SEWAGE DISPOSAL SYSTEM

MARYLAND STATE DEPARTMENT OF HEALTH

P 02680

HOWARD COUNTY

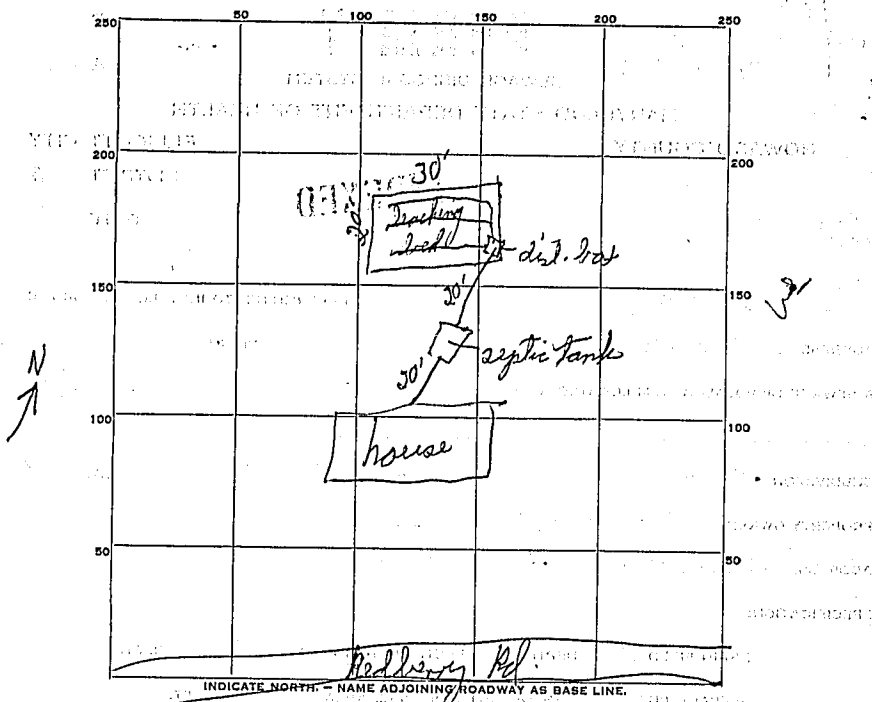
SEPTIC TANK CAPACITY 2-17-61 750 gal. 2000 GALLONS

*2-17-61 One 20 ft by 30 long leaching bed
located in rear of lot 30 ft from rear
house wall; depth of bed 6 to 7 ft.*
